Submission on Woden District strategy in draft new Territory Plan

Submission to ACT Government Draft Territory Plan and Woden District Strategy

COMMENTS ON NEW ACT PLANNING FRAMEWORK AND INNER SOUTH DISTRICT STRATEGY

Submission on Draft Territory Plan and Draft Technical Specifications

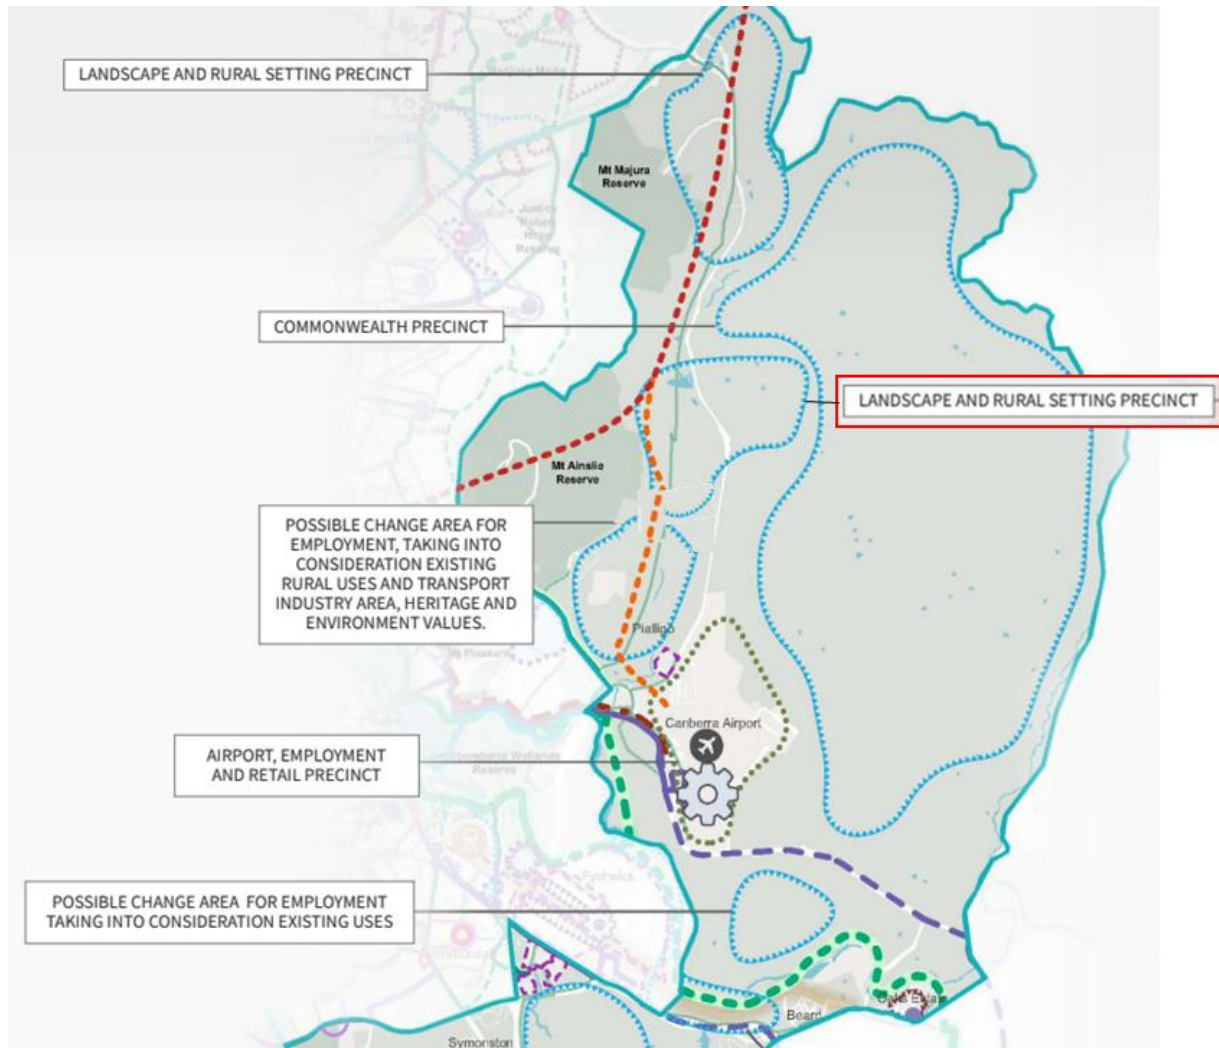
The central valley hosts numerous places, and aggregations of places, known for decades to have value in biodiversity (grassland, woodland, riparian), cultural heritage (Aboriginal, European, military, Federal uses) and water resources (surface and groundwater flow).

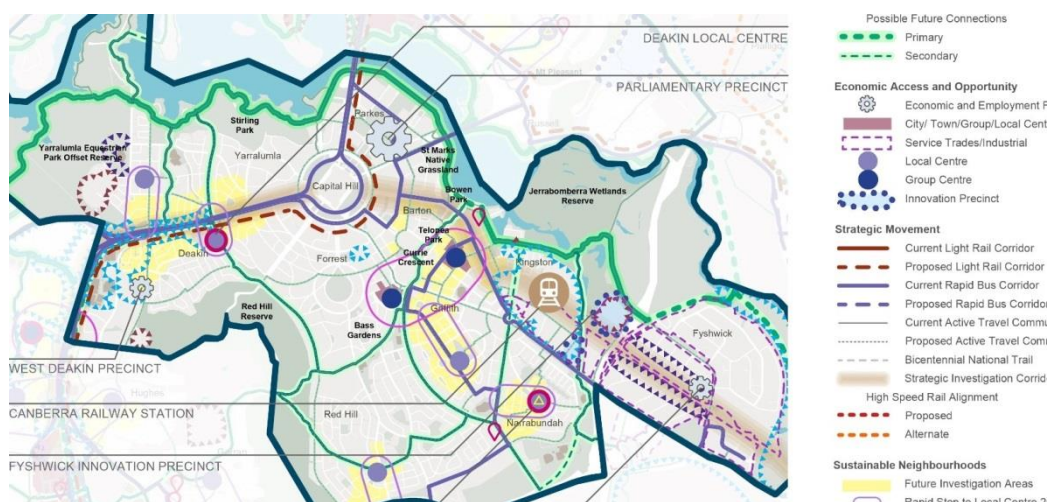
The Strategy Plan at page 10 of the Inner South District Strategy shows a large area of Yarralumla imprecisely covered in yellow highlighter, marked as "Future Investigation Area". This swathe of yellow covers my property so I am alarmed about the implications for my home and family.

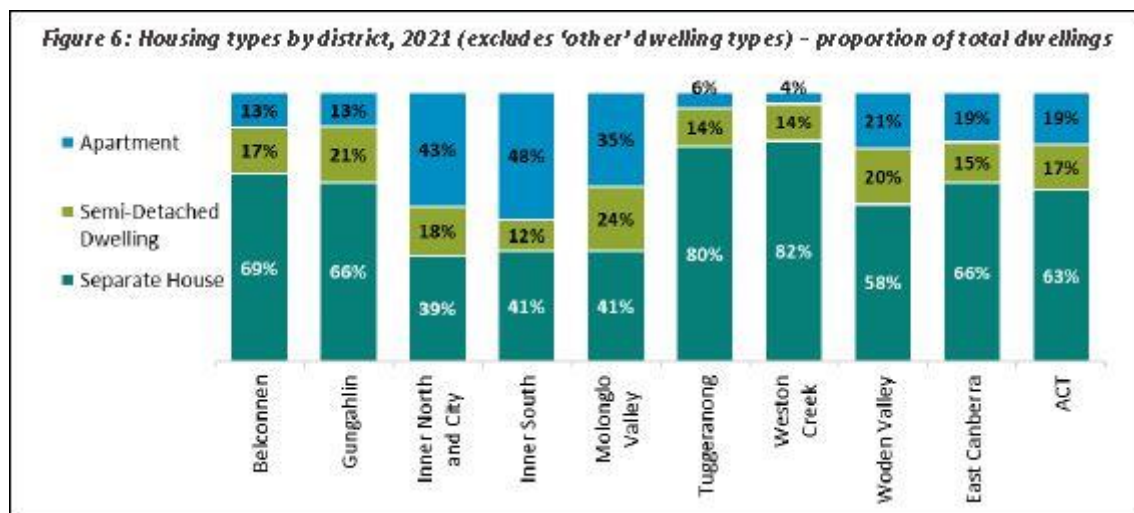
Figure 6, page 29 of the Inner South District Strategy shows the Inner South already has the largest proportion of apartments in Canberra. 48% of total dwellings in the Inner South are apartments, a greater proportion than any other district. The Canberra Brickworks development and the CSIRO Forestry redevelopment will add 730 new dwellings to Yarralumla, a massive 50% increase. The Inner South is already and comparatively highly densified with apartments, so should not be subjected to further infill and traffic congestion.

Comments on: Map 5: Molonglo Valley:

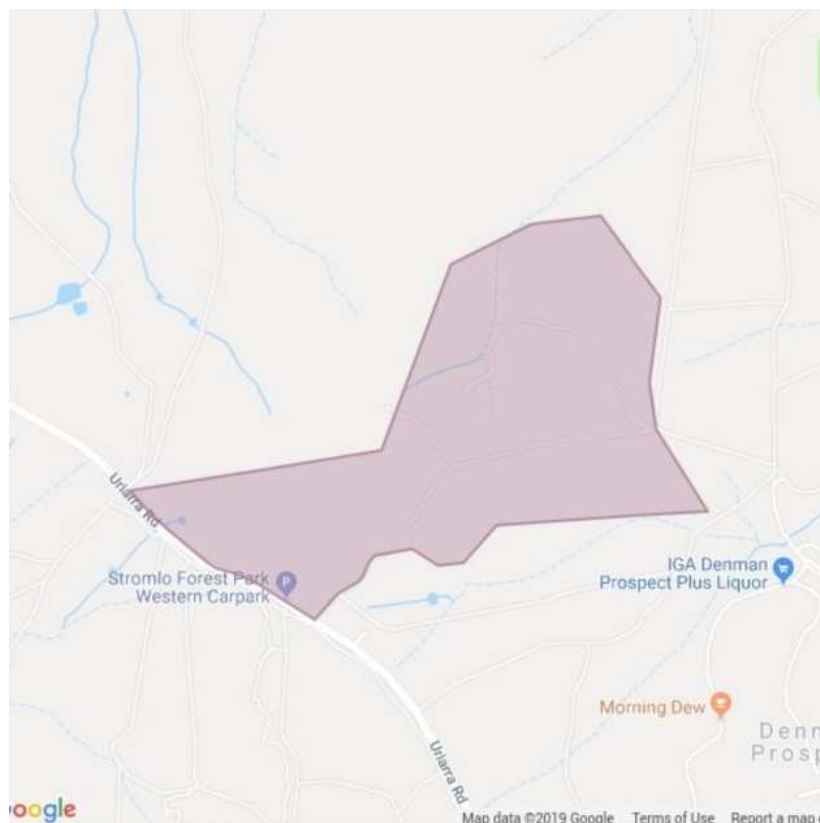
The Molonglo Valley map shows a large proportion of Blewett's Patch (aka Blewitt's Block or Piney Ridge) as 'FUA' – Future Urban Area. This is high value, biodiverse remnant habitat. It is a breeding

Above: 'Blewitt's Block', also known as Piney Ridge.

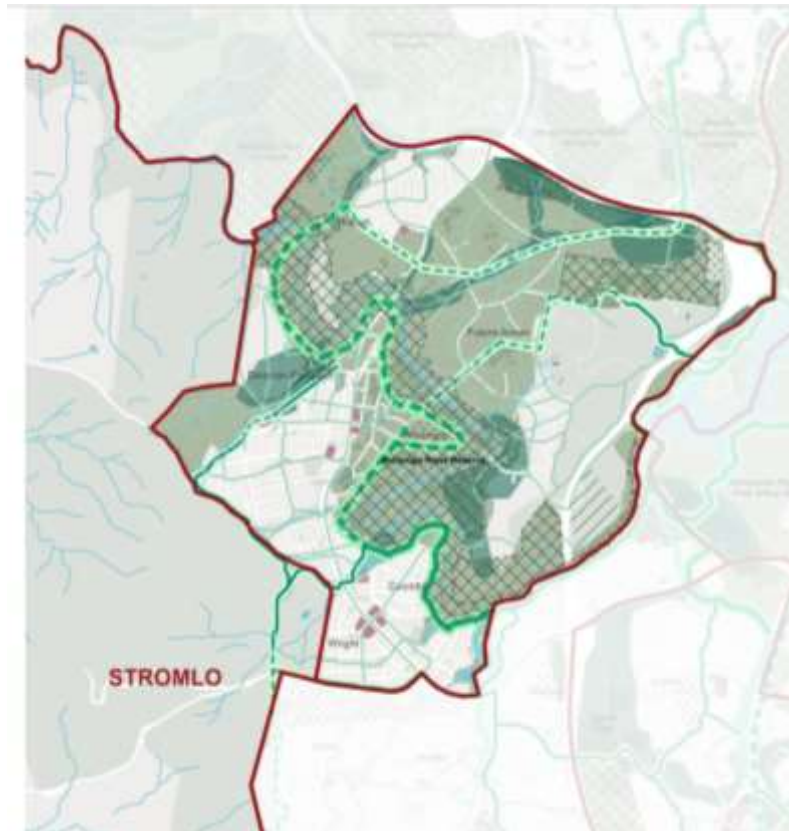
Comparing the The Molonglo District Strategy (above) with the satellite photo of the same area in the previous photos, it would appear that the ‘future urban area’ (indicated in Territory Plan Map 5) includes substantial amounts of forested area. This may simply be due to an error in designating it FUA? Clarification is needed.
